Planning and Zoning Board Agenda April 16, 2019

PLANNING AND ZONING BOARD MEETING AGENDA
--

- D. Site Plan - San Felasco Tech City Phase 2: A request by Clay Sweger, AICP, LEED AP, of EDA Engineers – Surveyors – Planners, Inc., applicant and agent for The Laser Investment Group, LLC, property owner, for consideration of a Site Plan to construct three (3) buildings – consisting of two (2) ±30,100 square foot buildings and one (1) ±6,000 square foot building – with associated paving, grading, drainage, and infrastructure improvements, on a ±55.36 acre subject property, consisting of a ±12.06 acre project area, located in the 12000 block of NW US Highway 441; Tax Parcel Number 05962-002-000; FLUM: Commercial and Industrial; Zoning: Commercial Intensive (CI) and Light & Warehouse Industrial (ILW) (Quasi-Judicial Hearing).

Designed: DJM	Sheet No.:
Drawn: JAB/MAB	C101
Checked: SJR	
Date: 03/26/19

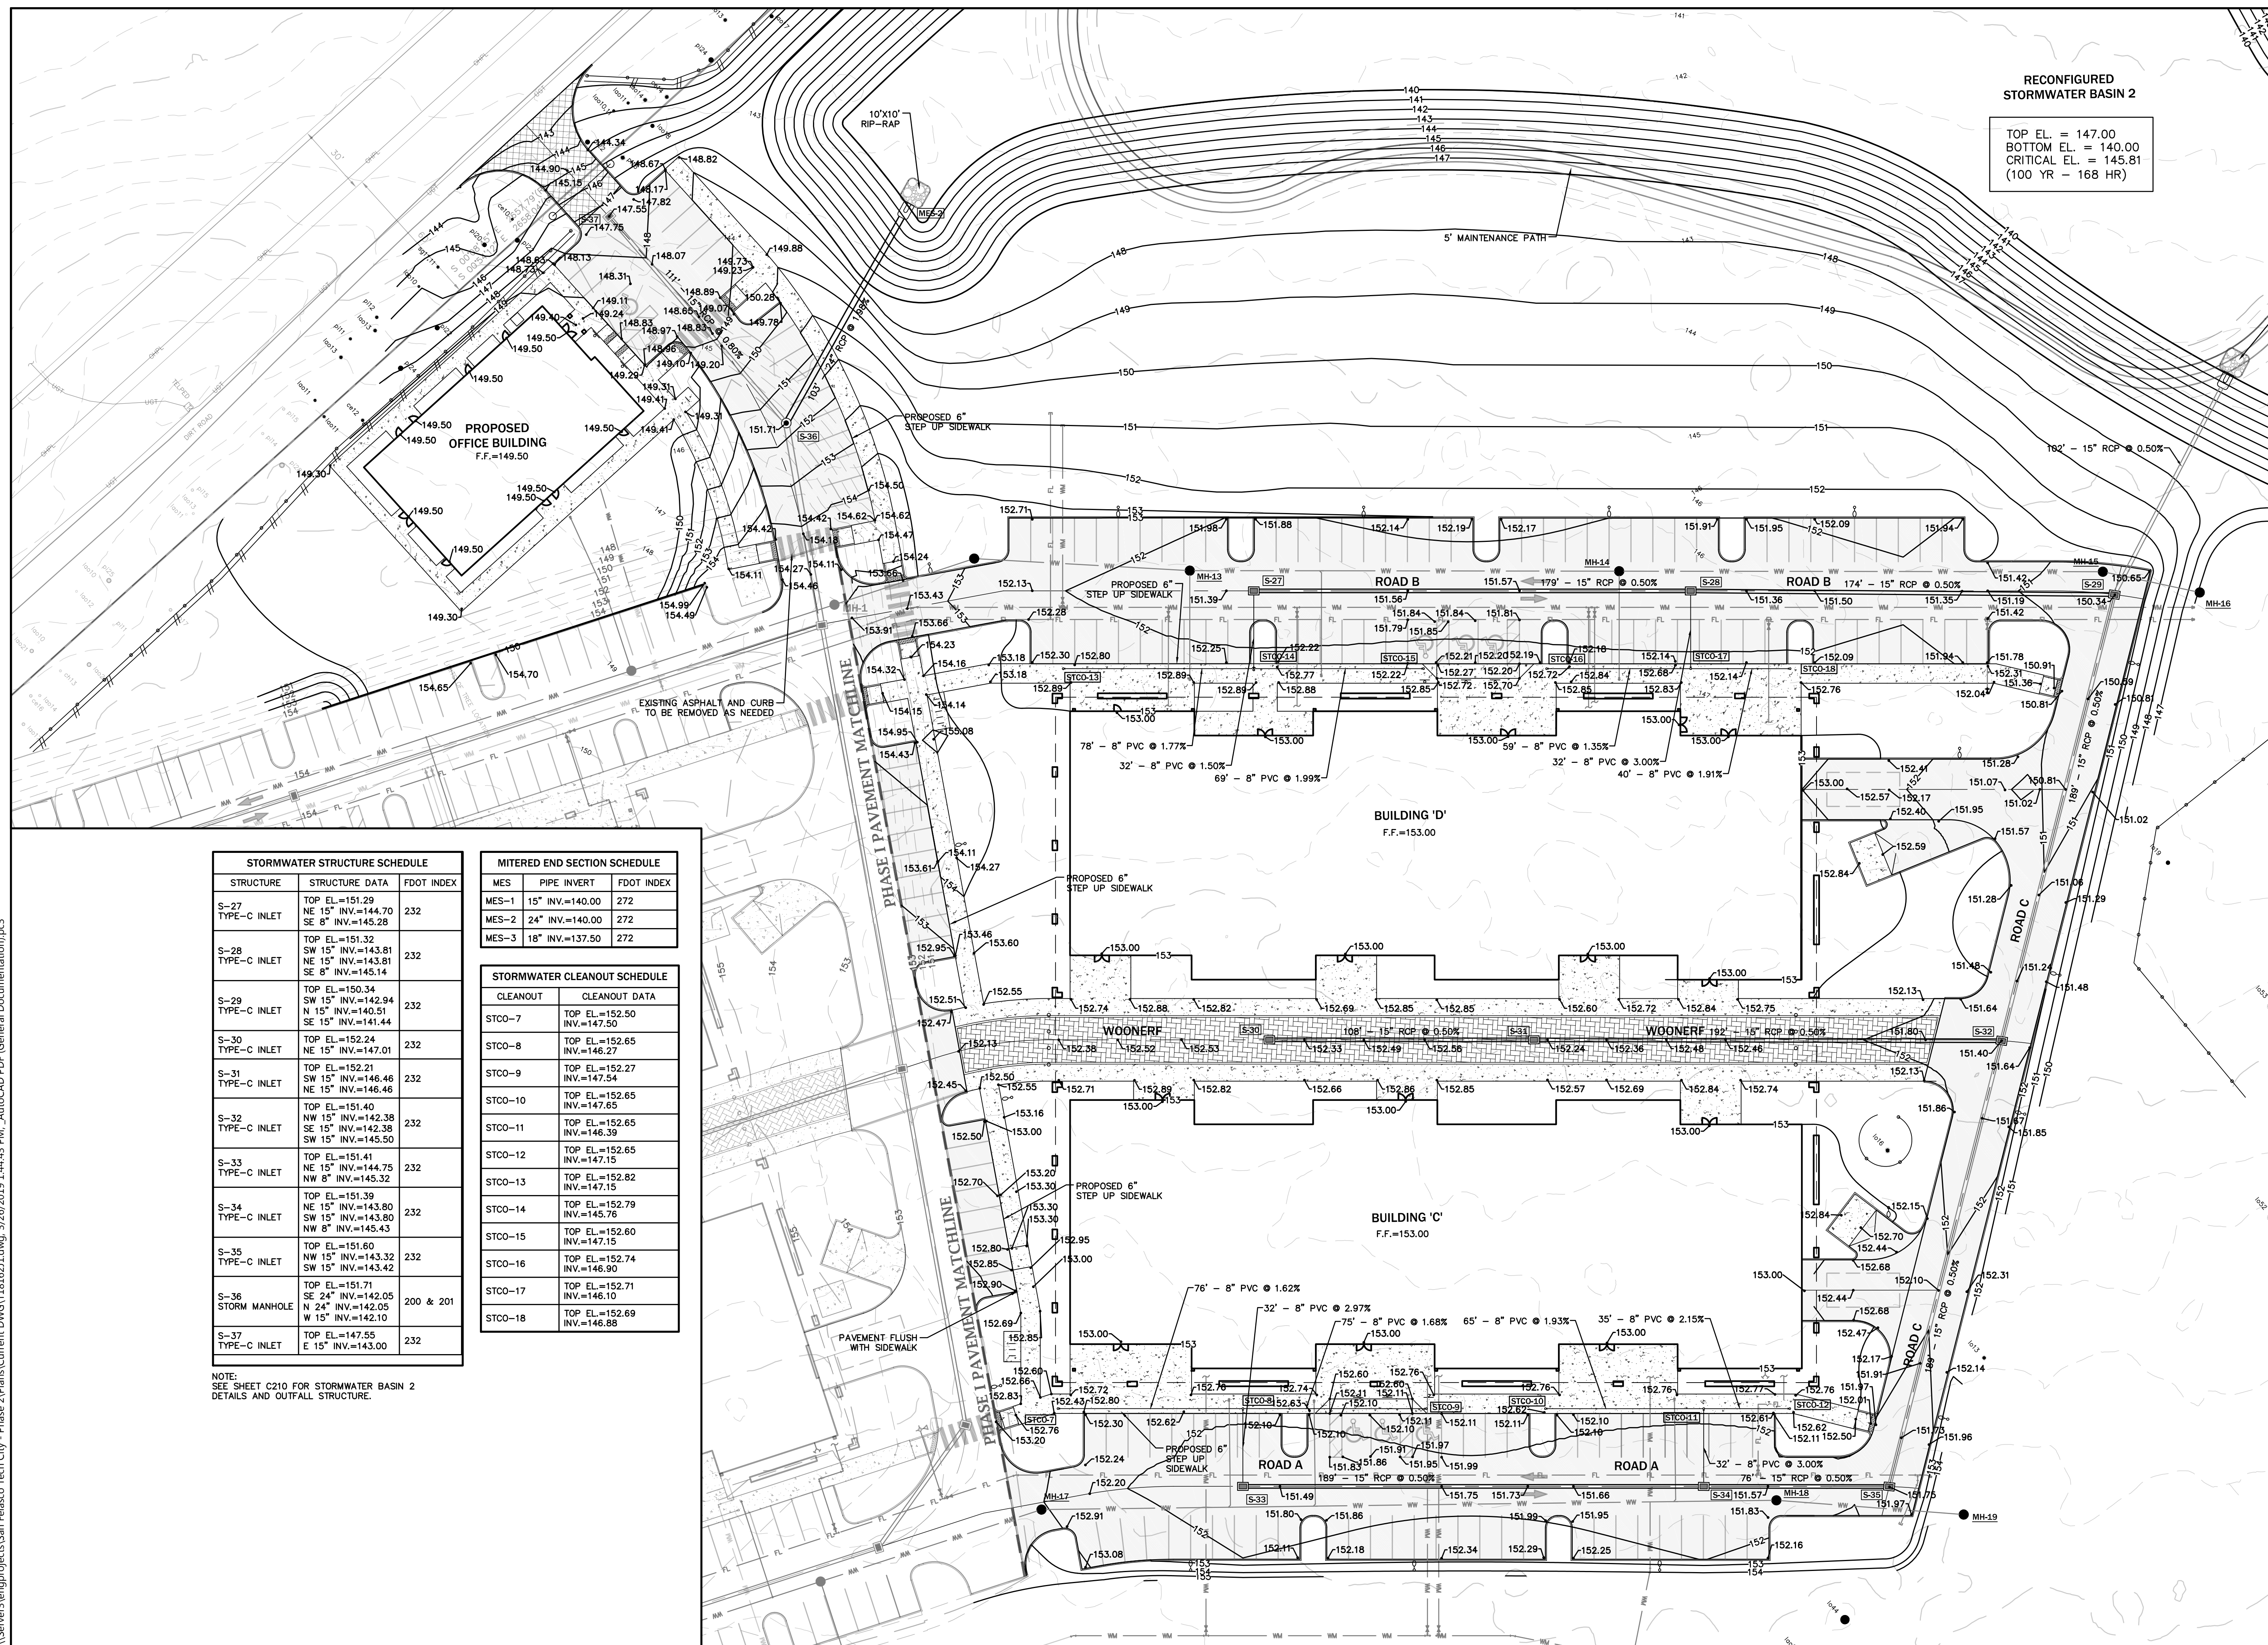
Remaining Issues: (a) Sheet C101 depicts 5 bicycle racks near Building D, however, the note states 8 bicycle parking spaces / 4 racks. (b) No bicycle parking provided for the 'office building'. Per 6.1.4(D), bicycle parking facilities shall be located within 50 linear feet of the building's front facade, and located near the building's main entrance where feasible. Two bicycle parking spaces are required for this building.

Remaining Issues: (a) Sheet C101 depicts 5 bicycle racks near Building D, however, the note states 8 bicycle parking spaces / 4 racks. (b) No bicycle parking provided for the 'office building'. Per 6.1.4(D), bicycle parking facilities shall be located within 50 linear feet of the building's front facade, and located near the building's main entrance where feasible. Two bicycle parking spaces are required for this building.
 - b. Crosswalks not provided to connect sidewalks / woonerf between Buildings A & B and Buildings C & D. Provide crosswalks meeting the criteria set forth in Section 6.1.10(A).

RESPONSE: A bicycle rack has been added to the proposed office building and the callout for the bicycle racks near Building D has been corrected. Please see revised sheet C101.

RESPONSE: Bicycle parking has been added to plans at southern end of Buildings C and D. Please see revised sheet C101.

RESPONSE: Crosswalks have been added. Please see revised sheet C101.

RESPONSE: Dimensions have been added to drive aisles. Please see revised sheet C101.

RESPONSE: Dimensions have been added to loading areas. Please see revised sheet C101.

RESPONSE: Bike racks have been added near the southern end of the proposed buildings. Please see revised sheet C101.

RESPONSE: Disabled parking spaces have been relocated. Please see revised sheet C101.

DATE	02/18/19	
JOB	D_19027	
DRAWN BY	JAD, JG	4
JAD		
A200	OF	
Schematic

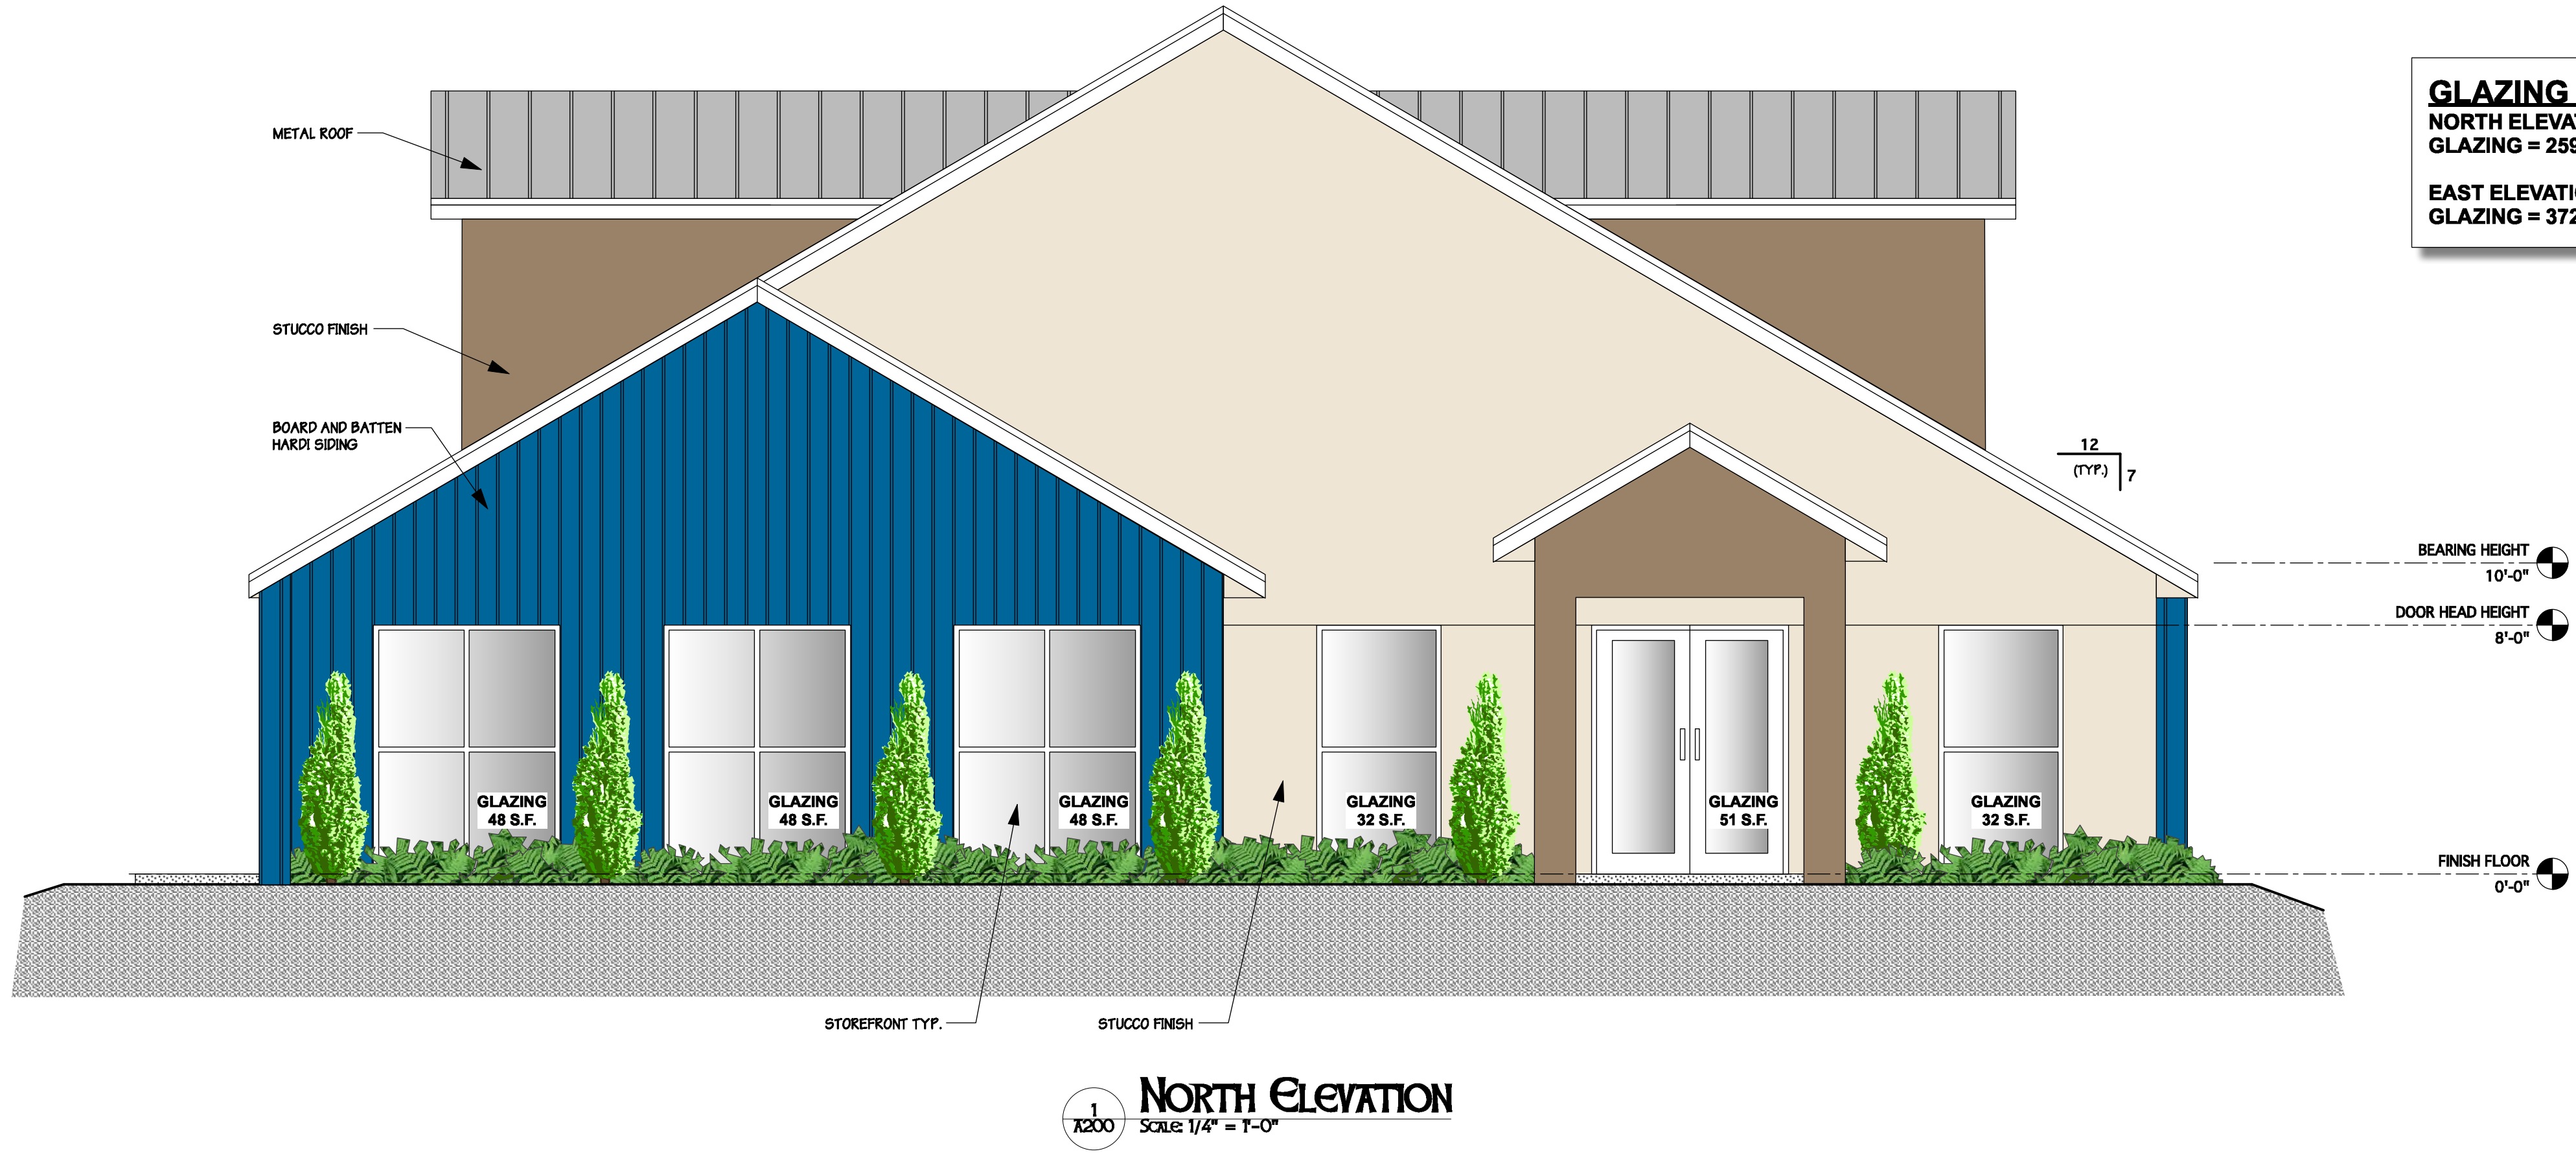
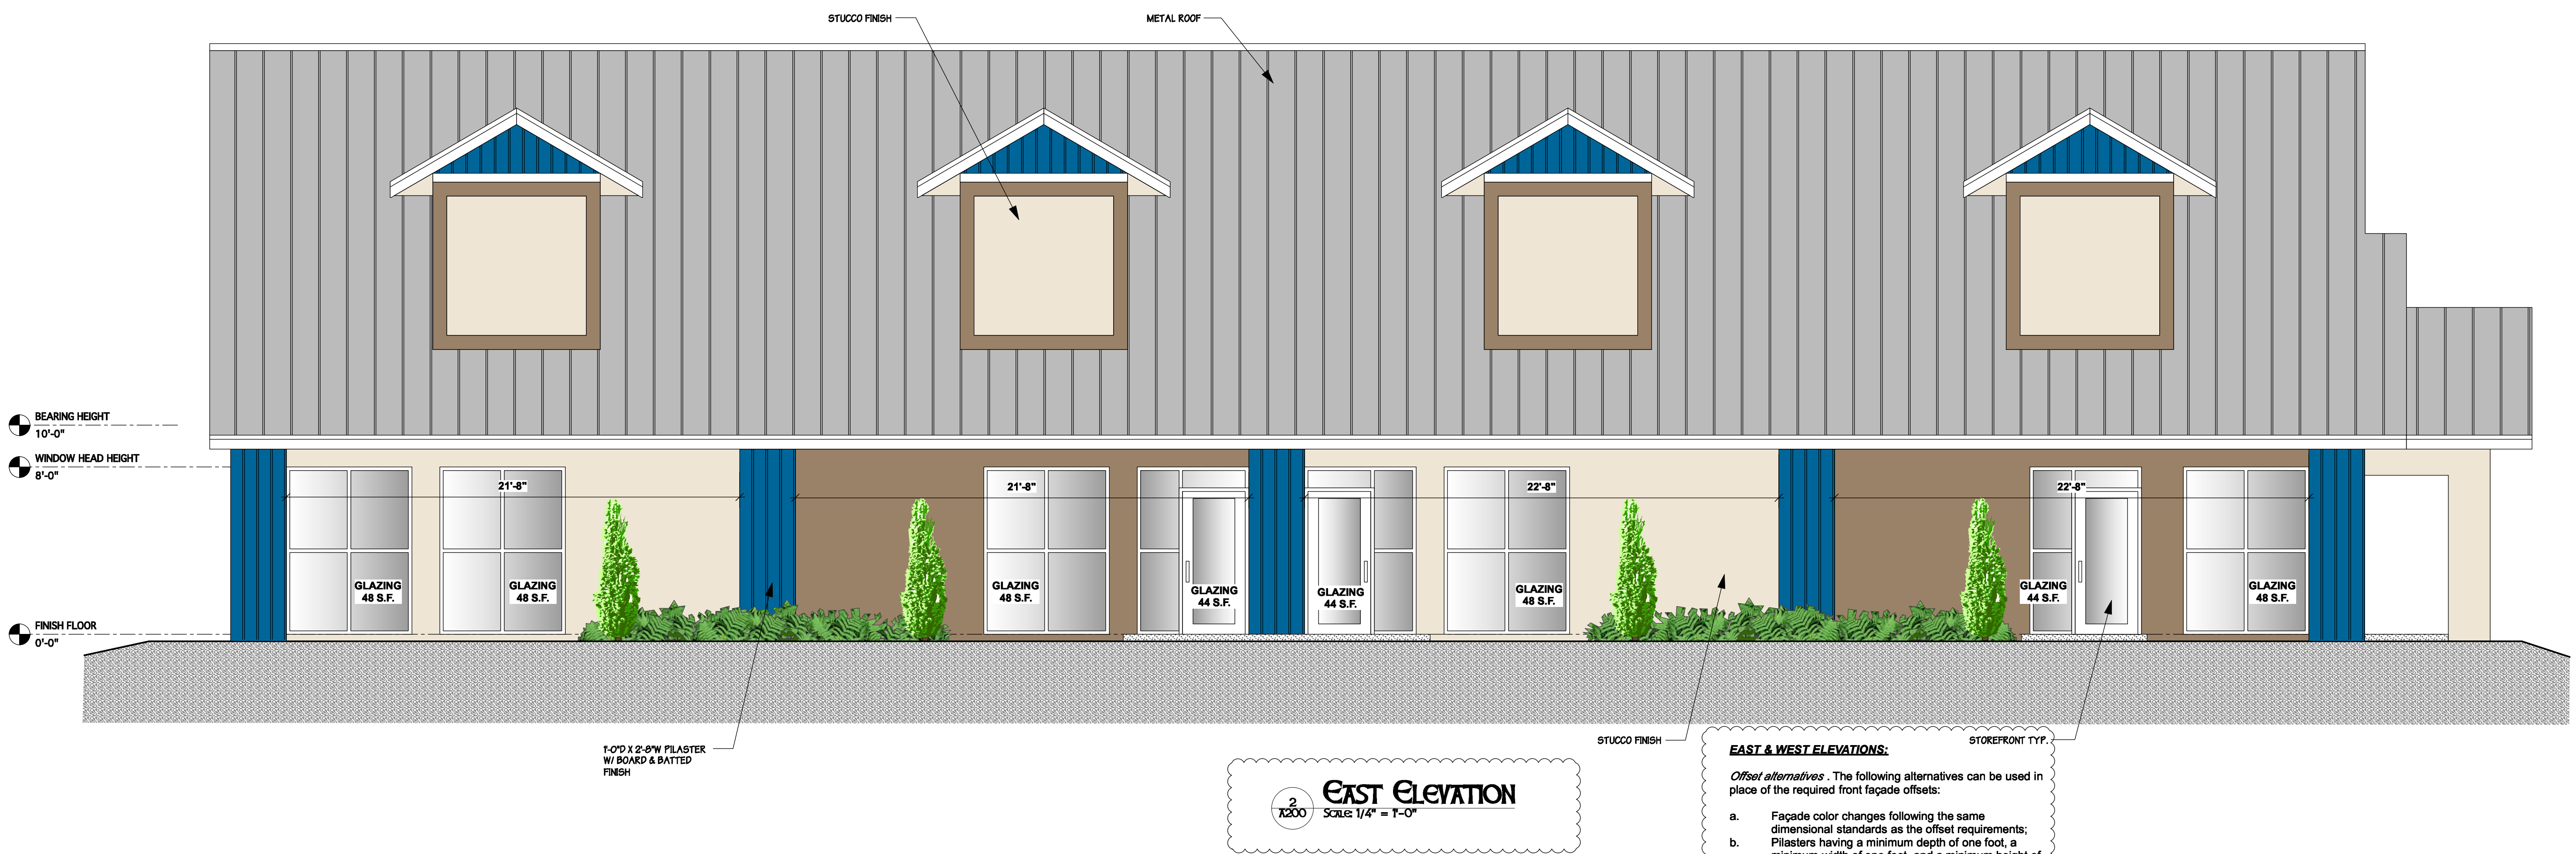
Remaining Issue: The architectural plans submitted on 3/14/19 do not provide calculation of the ground floor façade area or of the glazing provided to demonstrate compliance with Section 6.8.2(A). Please add these calculations on to Sheet A200.

- Glazing % = $1,143 \text{ sf} / 3,366 \text{ sf} \times 100 = \pm 34\%$
 - Sheet A200 (Color) demonstrates the façade glazing calculation.
- b. Detail depicting façade massing, or alternative selected to meet massing alternative requirements; and,

- Sheet A200 (Color) demonstrates the façade massing calculation.
- c. Color architectural plans depicting the color of all materials used in facades.
- Per LDR §6.8.2(A)(2)(c)(i), a minimum of 25% of the materials utilized for each side façade and rear façade shall be the same as the materials utilized for the front or street-facing façade.

- Sheet A200 (Color) demonstrates the color of all materials.
5. Site Plan Attachment #4: Fire Department Access & Water Supply.
 Action Needed to Address Deficiency:
